# Revisions to Operator-Submitted EC Data for Sundry Notice #453610

Well Name: Caballo 23 Fed #706H

# Caballo 23 Fed #706H Lea County, New Mexico

# PECOS DISTRICT DRILLING OPERATIONS CONDITIONS OF APPROVAL

## WELL LOCATION AND ACREAGE DEDICATION PLAT

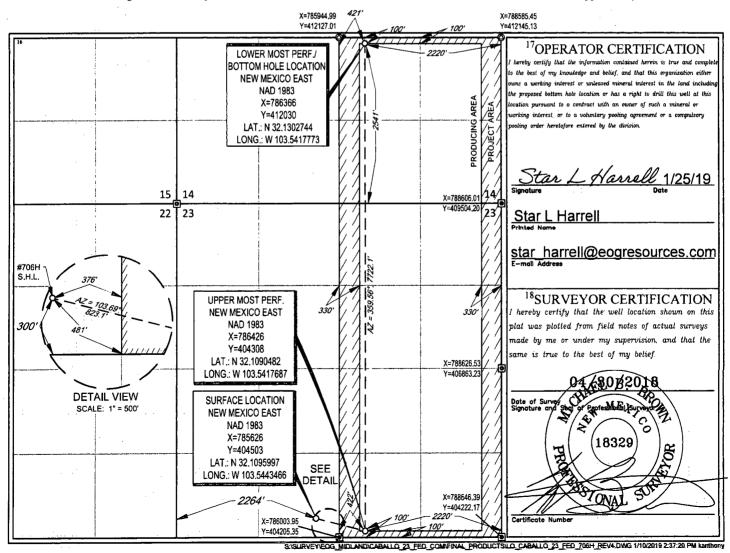
testing has been completed. Final Ab determined that the site is ready for fi EOG respectfully requests an BHL, casing design & cement. Change BHL to : 2,541? FSL	andonment Notices must be filed o nal inspection. amendment to our approved 2,220? FEL SEC 14-25S-33	aly after all requirements, includ APD for this well to reflect	changes in t	have been completed the bad Ficlo	and the operator has
testing has been completed. Final Ab determined that the site is ready for fi EOG respectfully requests an BHL, casing design & cement. Change BHL to : 2,541? FSL Change casing & cement desi Attached please find the follow	andonment Notices must be filed o nal inspection. 2,220? FEL SEC 14-25S-33 gn in accordance with the att ving supporting documentatio	APD for this well to reflect	ing reclamation, changes in t Carls	have been completed the bad Field DCD Field	and the operator has
testing has been completed. Final Ab determined that the site is ready for fi EOG respectfully requests an BHL, casing design & cement. Change BHL to : 2,541? FSL Change casing & cement desi	andonment Notices must be filed o nal inspection. 2,220? FEL SEC 14-25S-33 gn in accordance with the att ving supporting documentatio	APD for this well to reflect BE ached drill plan.	ing reclamation, changes in t Callels Revised Perm	have been completed the bad Field DCD Field	and the operator has

<sup>1</sup> API Number	r		<sup>2</sup> Pool Code			<sup>3</sup> Pool Nam	e	
448	5	98094 WC-025 G-09 S253336D; Upper Wolfc						)
Code				<sup>5</sup> Property N	ame		'We	ll Number
1				CABALLO 2	23 FED		#	706H
No.				<sup>8</sup> Operator N	ame			levation
			EO	G RESOUR	CES, INC.		3	342'
				<sup>10</sup> Surface Lo	cation	· · ·	•	. <u>.</u>
Section	Township	Range	Lot Idn	Feet from the	North/South line	Feet from the	East/West line	County
23	25-S	33-E	-	300'	SOUTH	2264'	WEST	LEA
· · ·	I	<sup>11</sup> B	ottom Hol	e Location If D	ifferent From Surf	face		
Section	Township	Range	Lot Idn	Feet from the	North/South line	Feet from the	East/West line	County
14	25-S	33-E	-	2541'	SOUTH	2220'	EAST	LEA
<sup>13</sup> Joint or 1	infill <sup>14</sup> Co	nsolidation Code	15Orde	r No.	··· ·· ·· ·· ·· ··	· · · · •		
	4 54 8 Code No. Section 23	No. Section 23 Section 14 25-S Township 25-S	4         5         980           Sode	4         5         98094           Sode	4 5455       98094         Sode       *Property N         CABALLO       2         No.       *Operator N         EOG RESOURC       10         Section       Township         23       25-S         33-E       -         300'       11         Bottom Hole Location If D         Section       Township         Range       Lot Idn         14       25-S         33-E       -         25+S       33-E         -       2541'	4 555       98094       WC-025 G-05         Sode <sup>5</sup> Property Name       CABALLO 23 FED         No. <sup>6</sup> Operator Name       EOG RESOURCES, INC.         10 Surface Location         Section Township       Range         23       25-S       33-E       -       300'       SOUTH         11 Bottom Hole Location If Different From Surf         Section Township         Section Township         11 Bottom Hole Location If Different From Surf         11 Bottom Hole Location If Different From Surf         14       25-S       33-E       -       2541'       SOUTH	4 \$55         98094         WC-025 G-09 S253336D; L           Sode         'Property Name           CABALLO 23 FED           No.         'Operator Name           EOG RESOURCES, INC.           10 Surface Location           Section         Township           23         25-S           33-E         -           11 Bottom Hole Location If Different From Surface           Section         Township           Range         Lot Idn           11 Bottom Hole Location If Different From Surface           Section         Township           Range         Lot Idn           25-S         33-E           -         2541'           SOUTH         2220'	4 \$55       98094       WC-025 G-09 S253336D; Upper Wolfcamp         Code       *Property Name       *We         CABALLO 23 FED       #"         No.       *Operator Name       *E         EOG RESOURCES, INC.       3         10       Surface Location       3         23       25-S       33-E       -       300'       SOUTH       2264'       WEST         11 Bottom Hole Location If Different From Surface         Section Township       Range       Lot Idn       Feet from the       North/South line       Feet from the       East/West line         11 Bottom Hole Location If Different From Surface         Section       Township       Range       Lot Idn       Feet from the       East/West line         14       25-S       33-E       -       2541'       SOUTH       2220'       EAST

SHL: 300' FSL & 2,264' FWL, Section 23, T-25-S, R-33-E, Lea Co., N.M. BHL: 2,541' FSL & 2,220' FEL, Section 14, T-25-S, R-33-E, Lea Co., N.M.
